IEEE 802.3 Maintenance

July 21st, 2005
San Francisco, CA
David Law
David_Law@3Com.com

Review of new request

1168 - Comparison of requirements

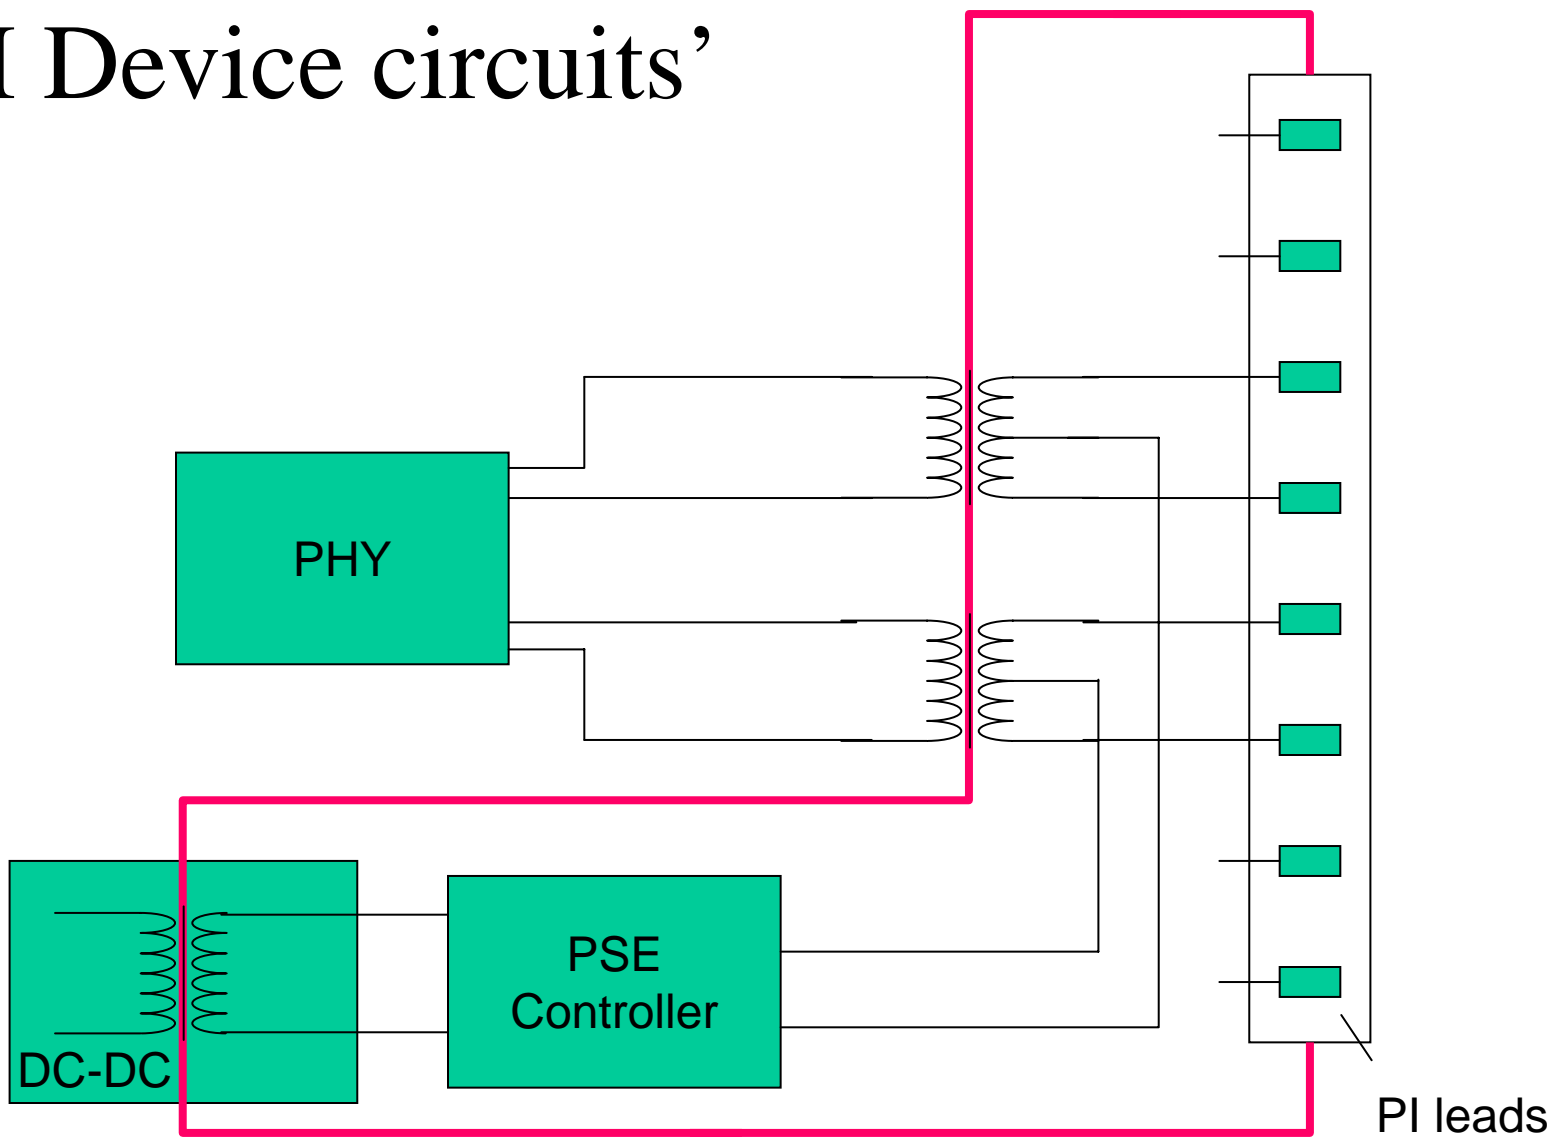
Isolation from all MDI leads to	AC and DC test			Impulse test	
		Vrms	Vdc	Test method	Impulse	Defined
10BASE-T	Frame ground and PHY device circuits	1500V	2250V	5.3.2 of IEC 60950:1991	2400V 1.2/50 us	IEC 60060
10BASE-T The PI of a PD within its MDI	Frame ground and all external conductors					
100BASE-T ^{Note 1}	Frame ground	1500V	2250V	5.3.2 of IEC 950:1991	2400V 1.2/50 us	IEC 60
1000BASE-T	Frame ground and PHY device circuits	1500V	2250V	5.3.2 of IEC 60950:1991	2400V 1.2/5 us	IEC 60060
1000BASE-T The PI of a PD within its MDI	Frame ground and all external conductors					
DTE Power via MDI	PI Device circuits	1500V	Not allowed	6.2 of IEC 60950-1:2001	1500V 10/700 us	6.2.2.3 of IEC 60950-1:2001

'PI Device circuits'
